PROJECT : HONOAPIILANI HIGHWAY
Kahana to Alaeloa

PROJECT NO.: F-030-1(13)

DRAINAGE

STATE OF HAWAII
DEPARTMENT OF TRANSPORTATION
LAND TRANSPORTATION FACILITIES DIVISION
DRAINAGE & IRRIGATION PLAN
HONOAPIILANI HIGHWAY
Kahana to Aiealoa
F.A. Proj. No. F-030-1(13)

NOTE:
Demolishing, removing and disposing of existing reinforced concrete headwall and cutting existing Arch Culvert shall be considered incidental to new 58' x 36' Arch Culvert.

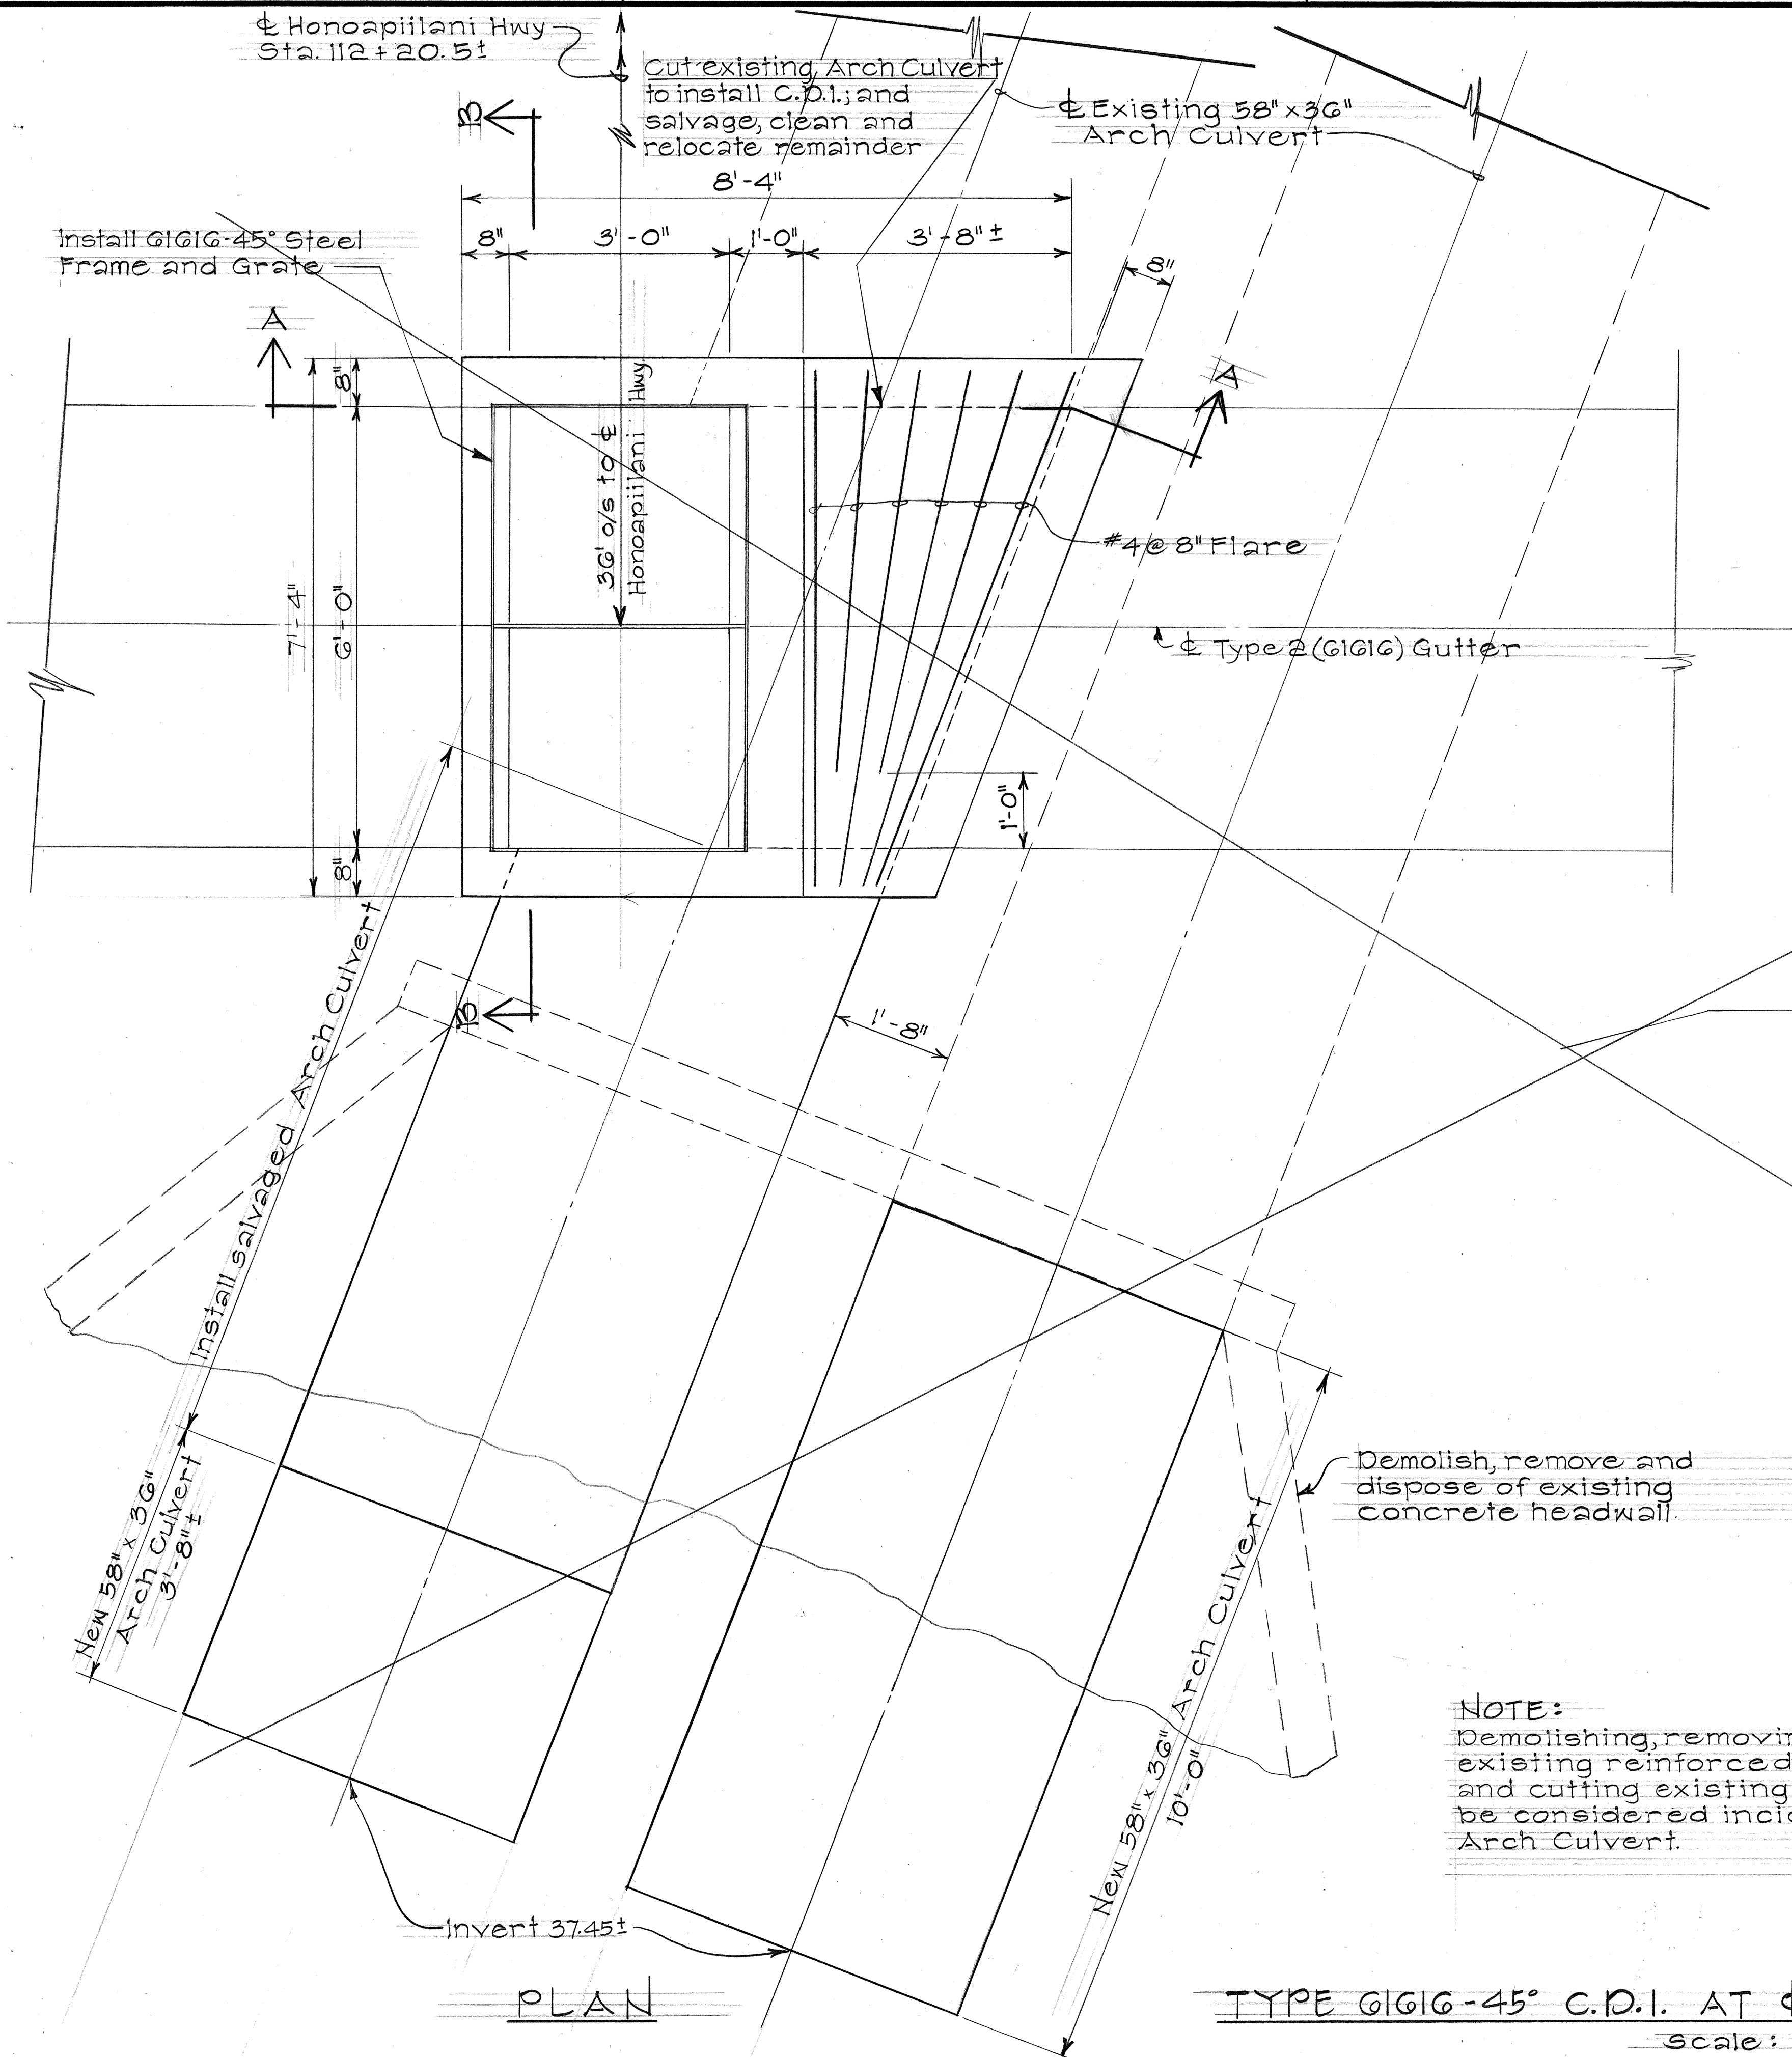
17 Sep '79 Tracing added to show details of drainage structures for new roadway intersection.

STATE OF HAWAII DEPARTMENT OF TRANSPORTATION LAND TRANSPORTATION FACILITIES DIVISION
DRAINAGE DETAILS
HONOAPIILANI HIGHWAY Kahana to Alaeos F.A. Proj. No. F-030-1(13)
Scale: As Shown Date: Sept., 1977
SHEET NO. 47 OF 51 SHEETS

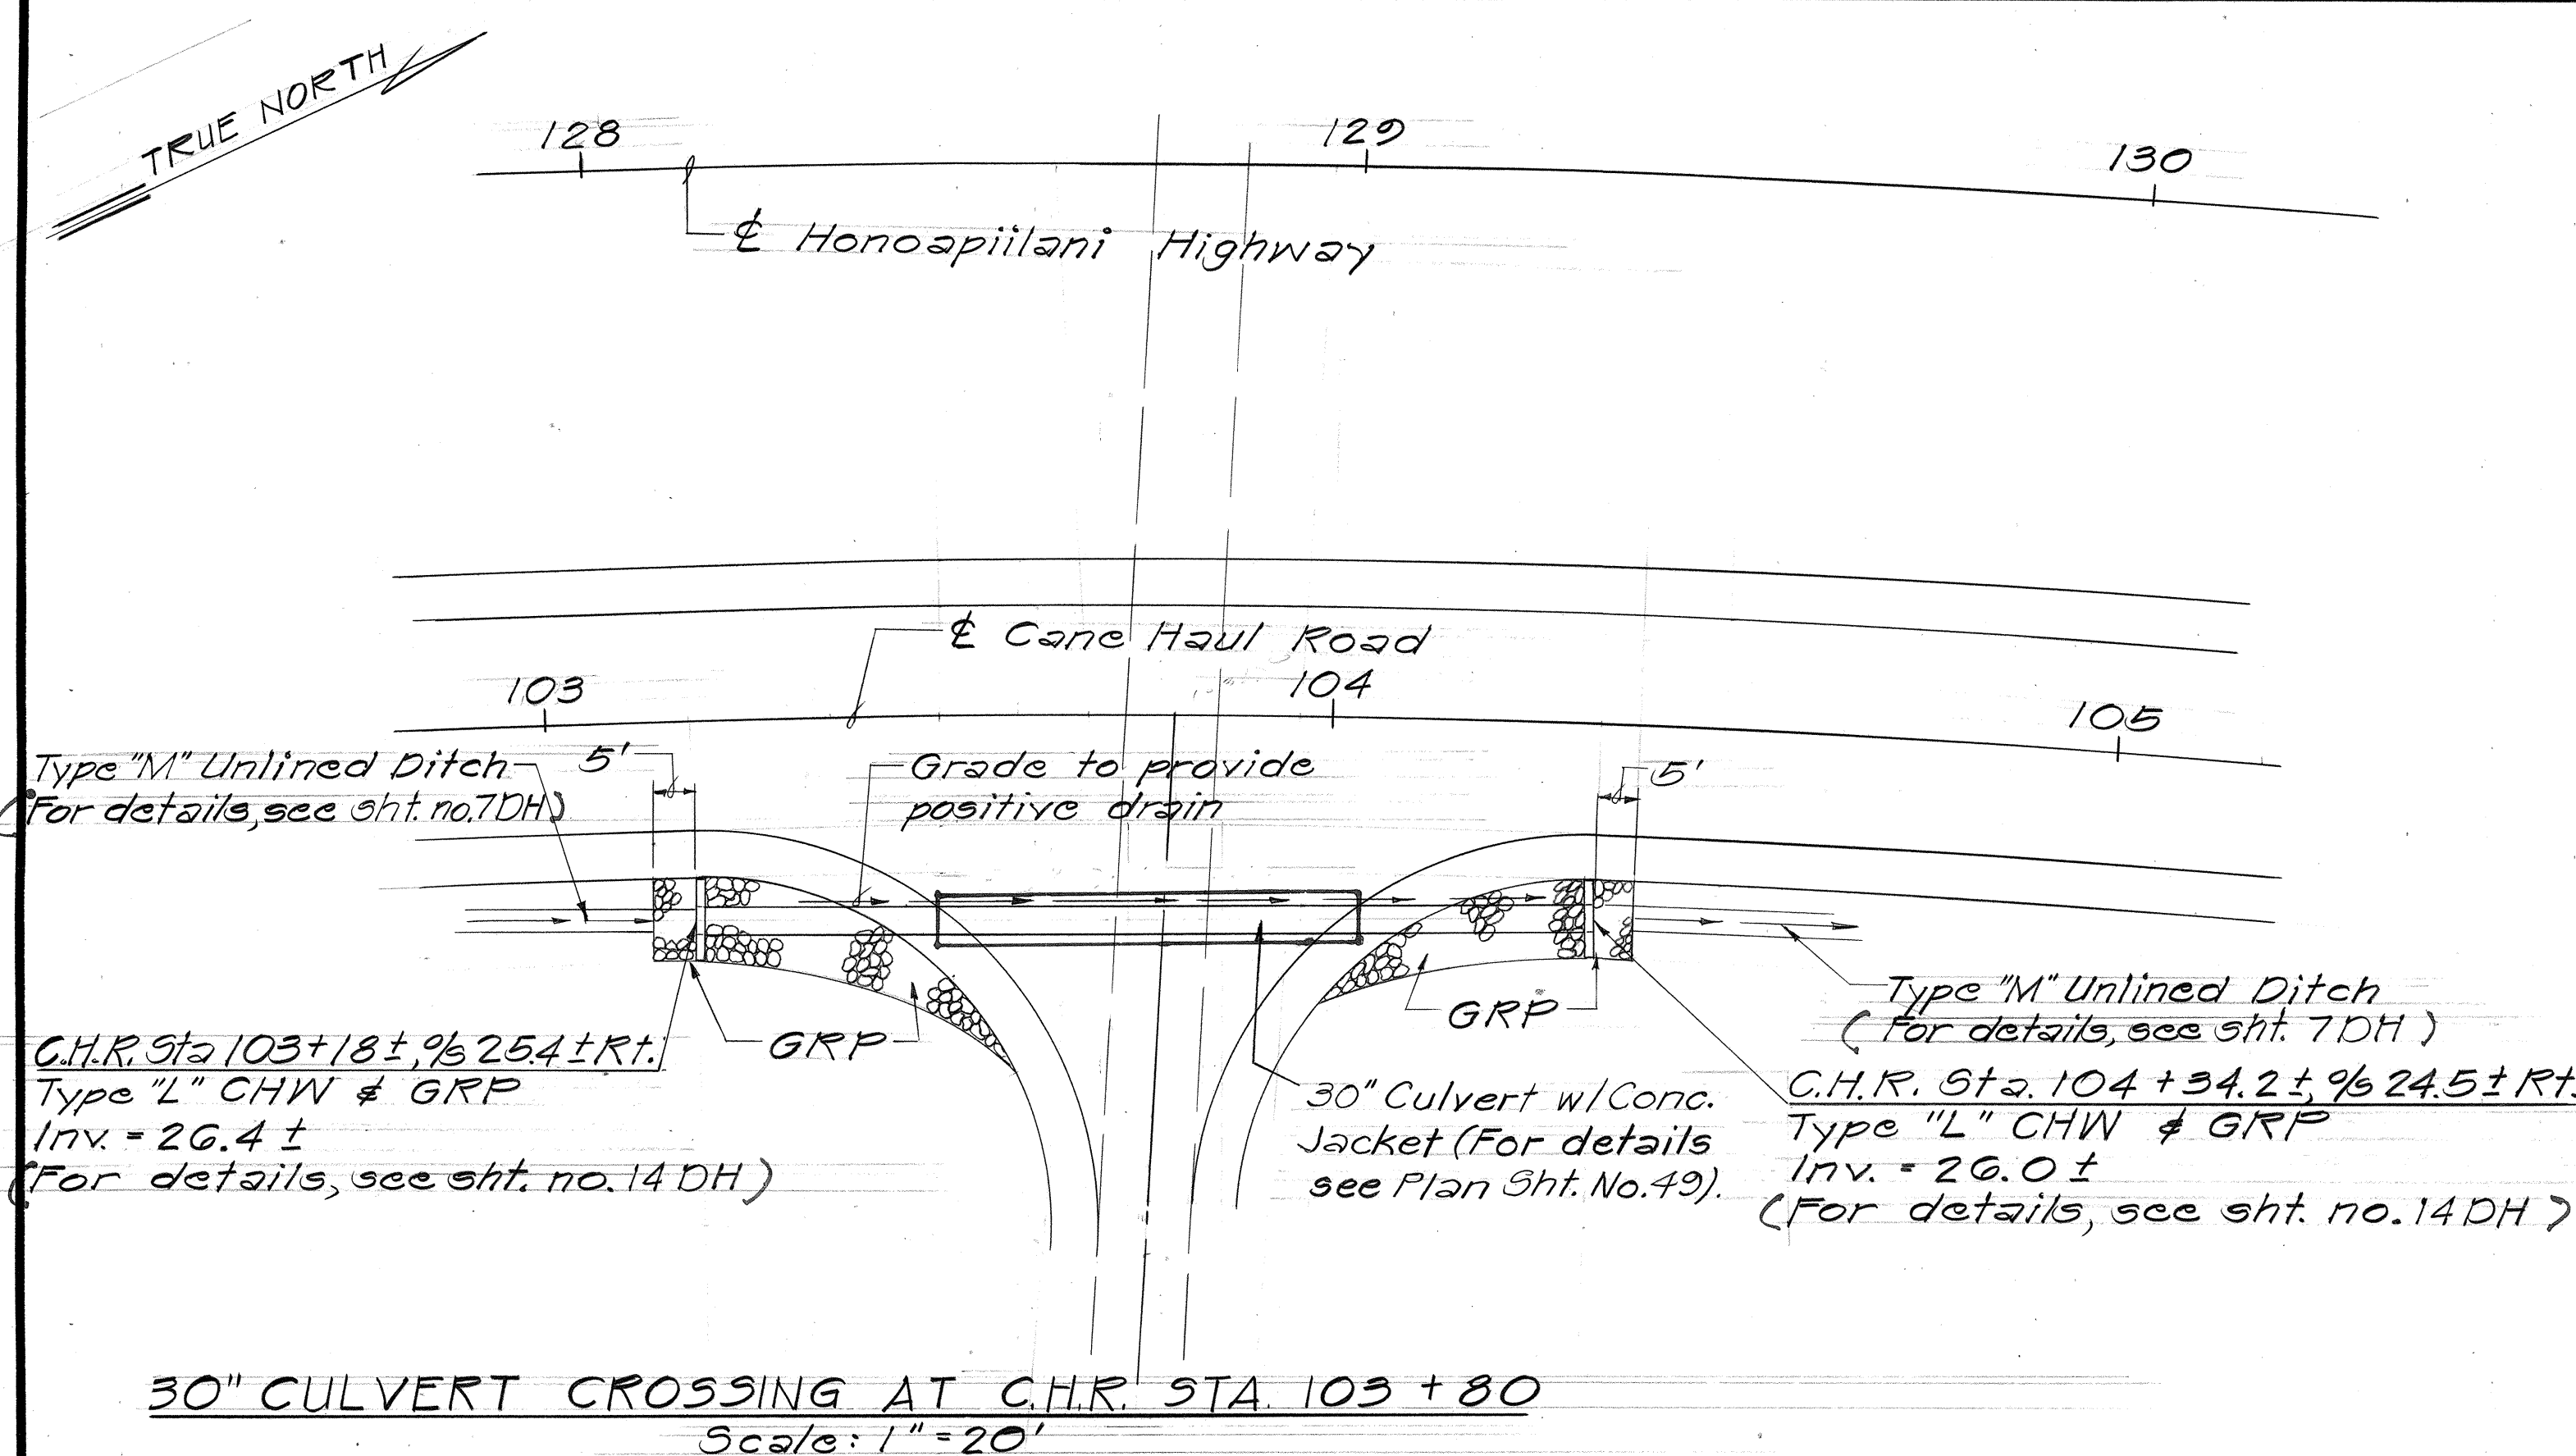
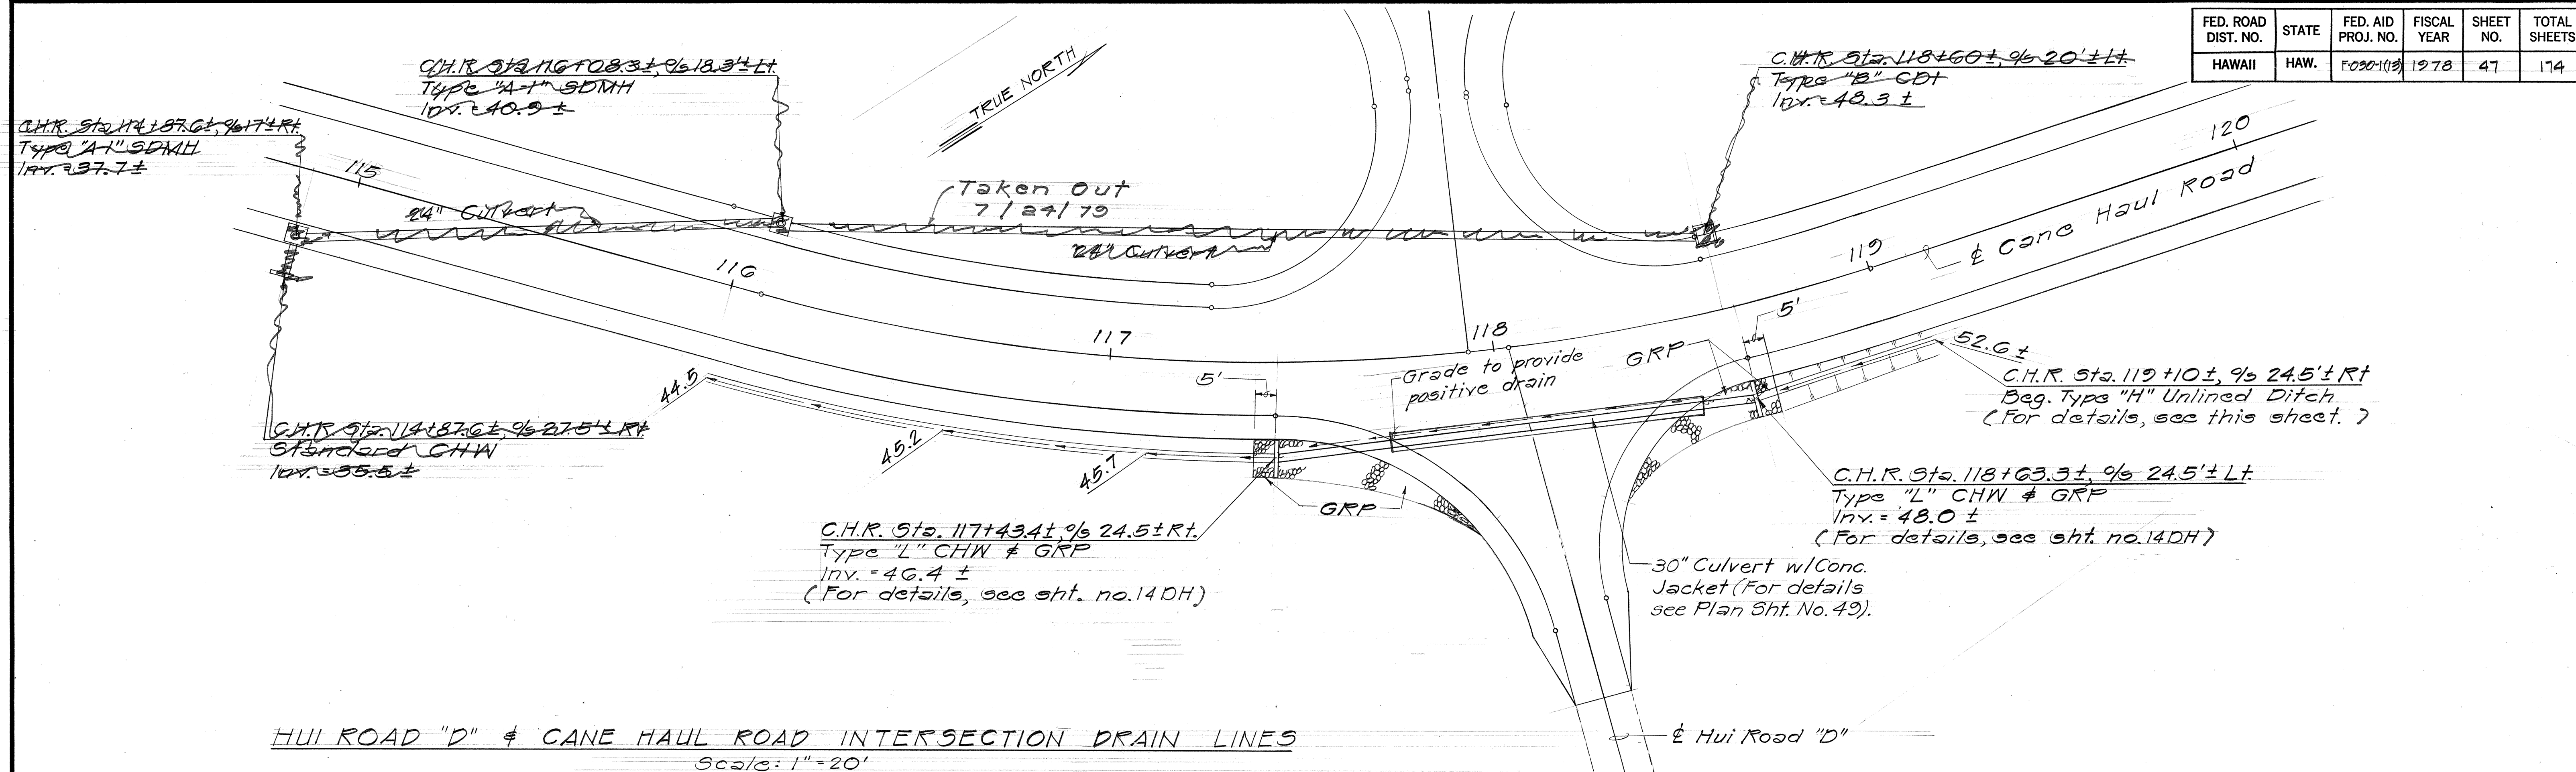
6/15/78	Included Concrete Jacket for 30" Culvert at C.H.R. Sta. 103+80 & Sta. 118+00 per Addendum No. 2.
DATE	REVISION
